INTERDISCIPLINARY SCIENCE BUILDING

MOCK-UP
ELEVATION AND PLANS

RE: Metal panel mock-up shop drawings Rev 2

RE: Metal panel mock-up shop drawings Rev 1

1
D1 TYP. VERTICAL PANEL JOINT SECT. DTL.
SCALE: FULL SCALE

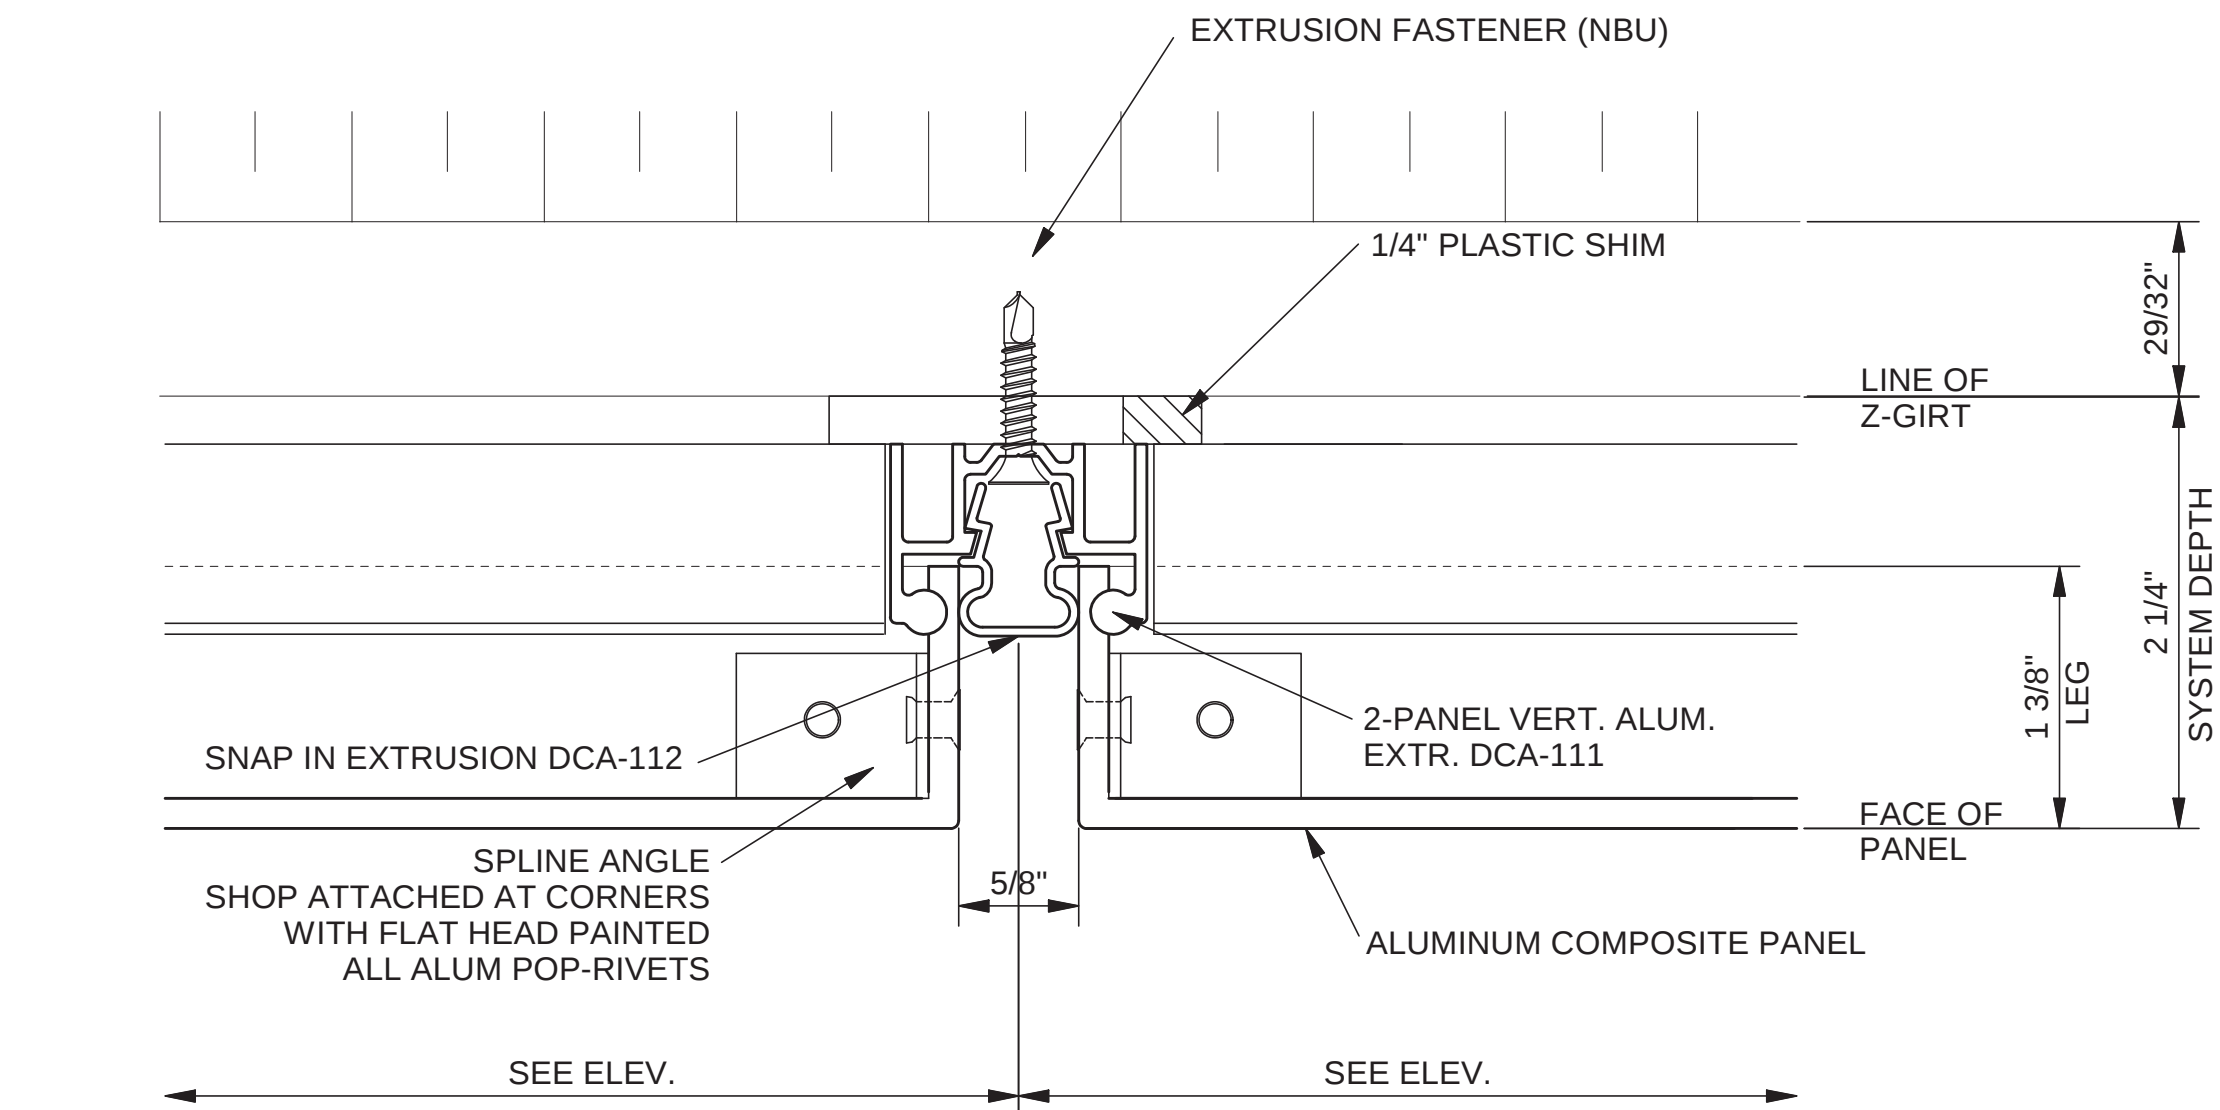
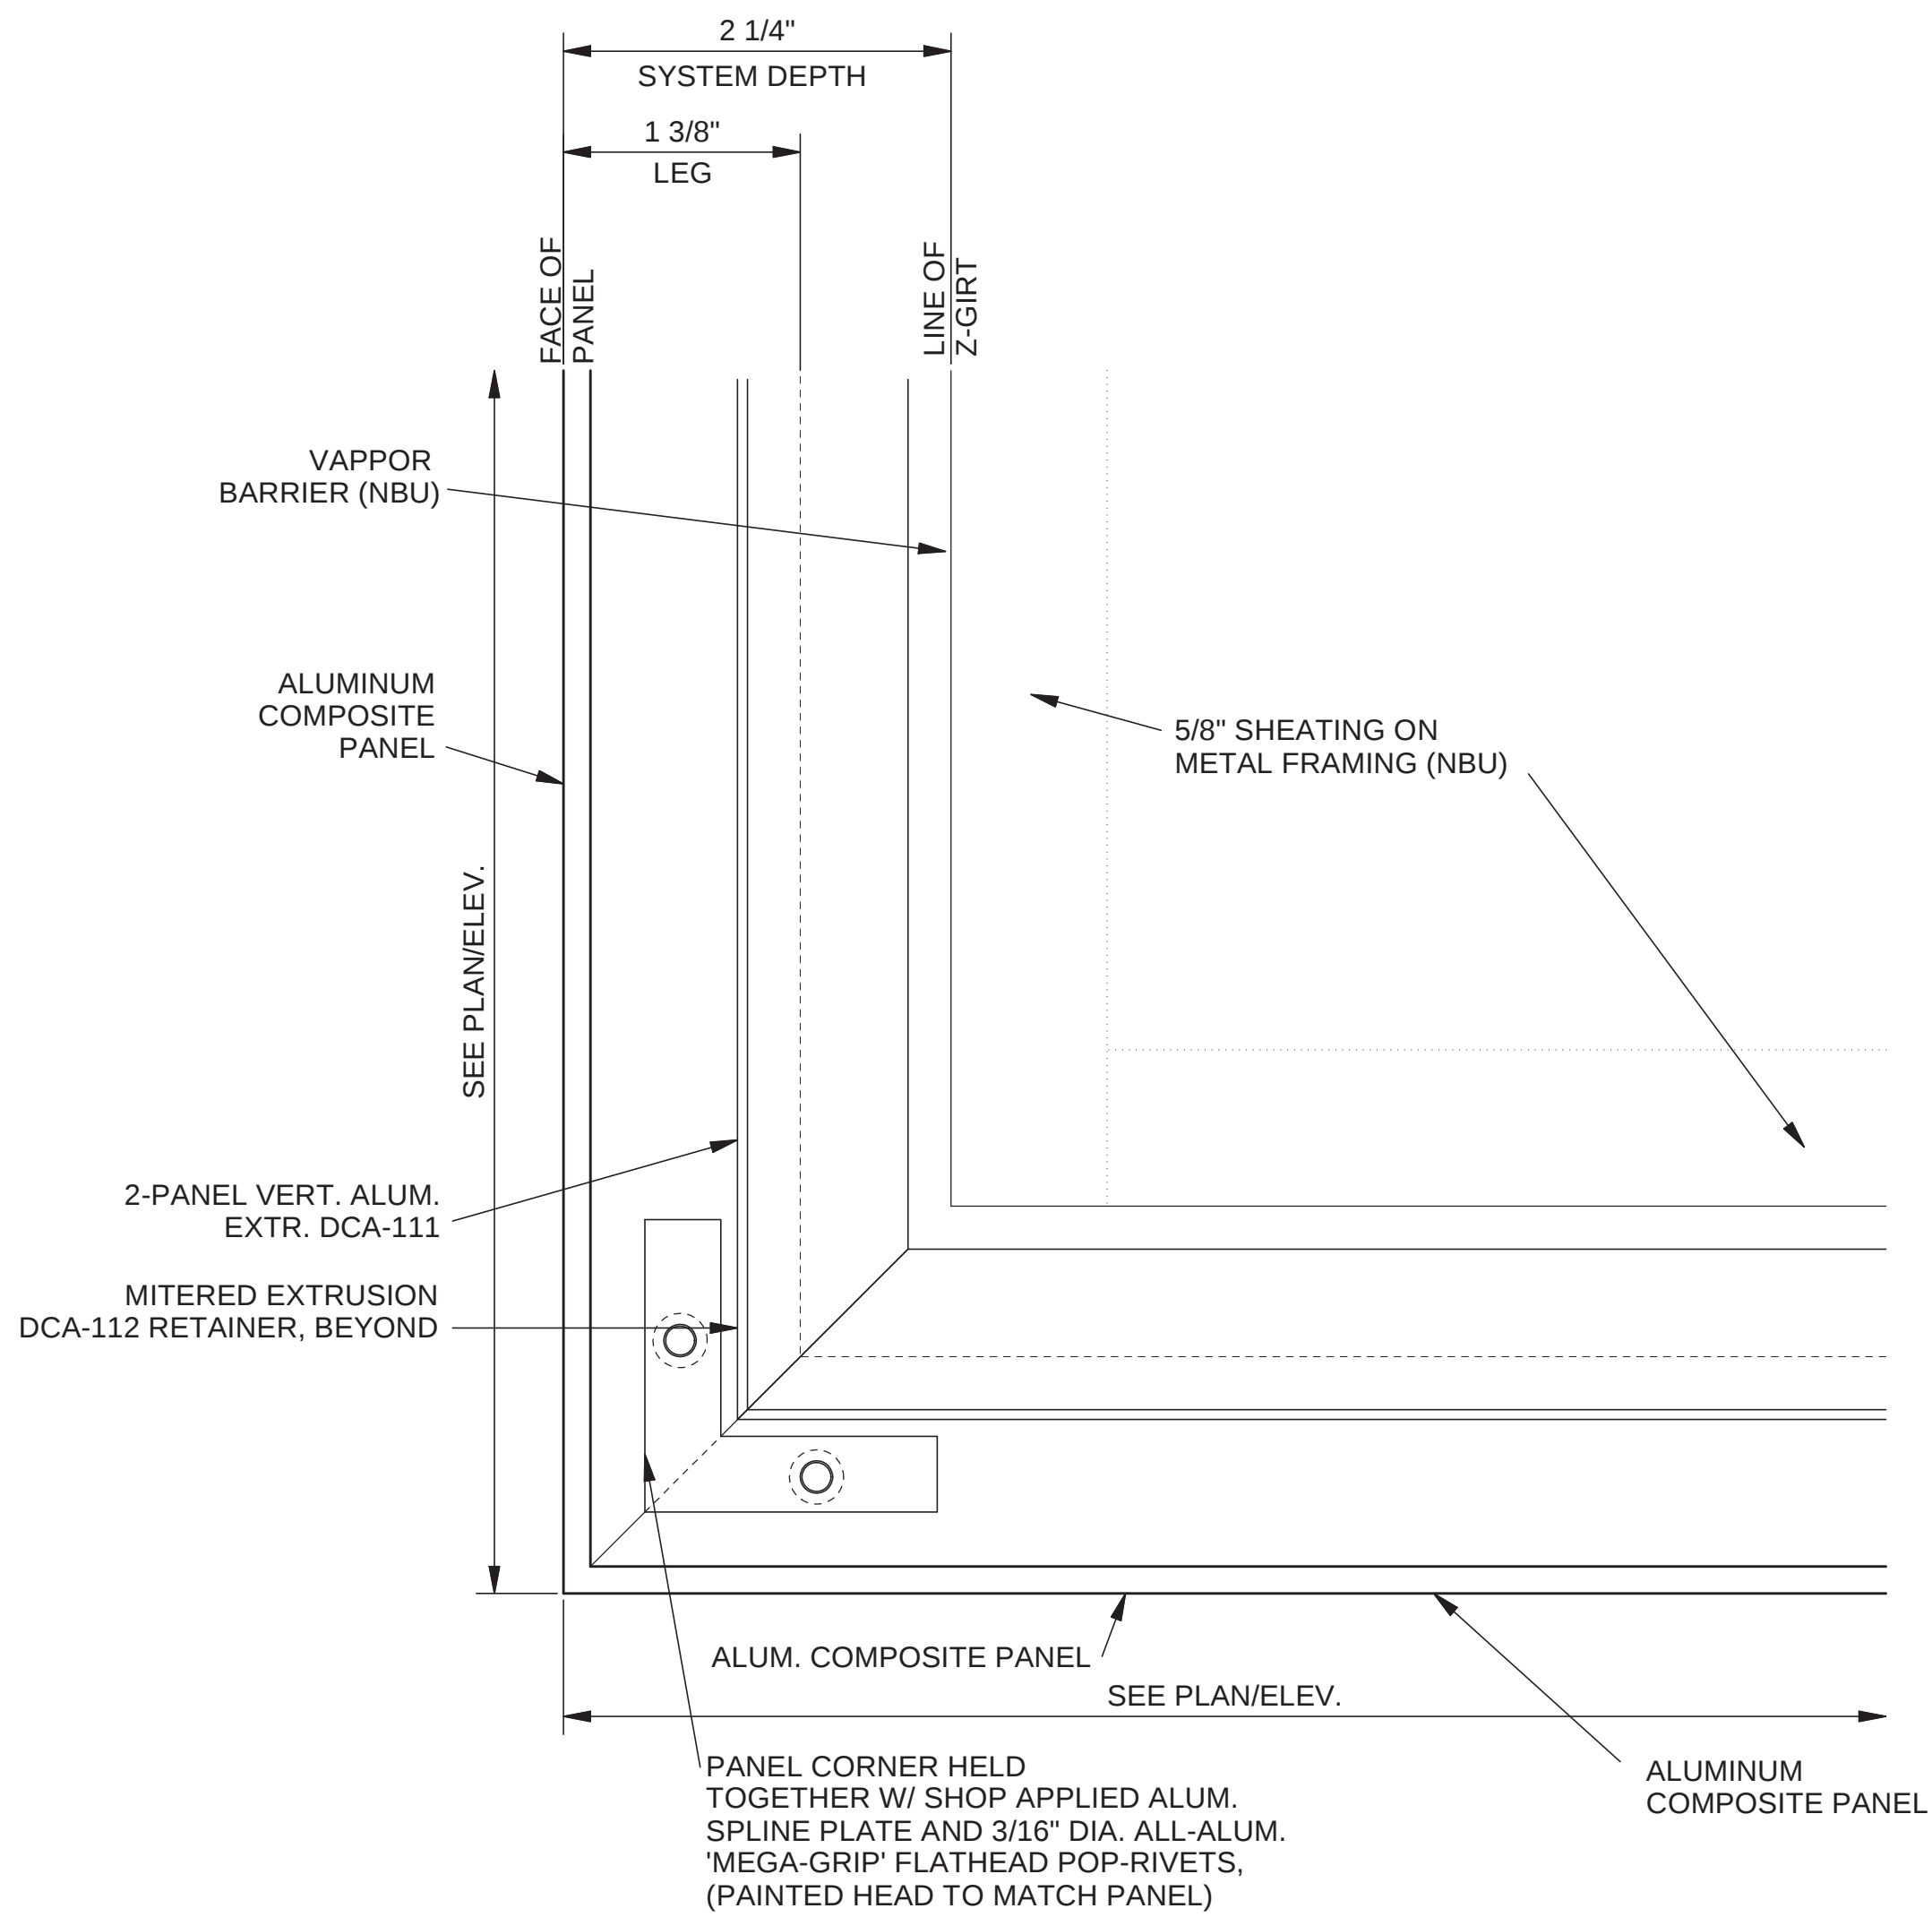
Contractor shall recommend suitable orientation of fiberglass clip for the installation of the alumn. composite metal panels.

Contractor shall recommend suitable orientation of fiberglass clip for the installation of the alumn. composite metal panels.
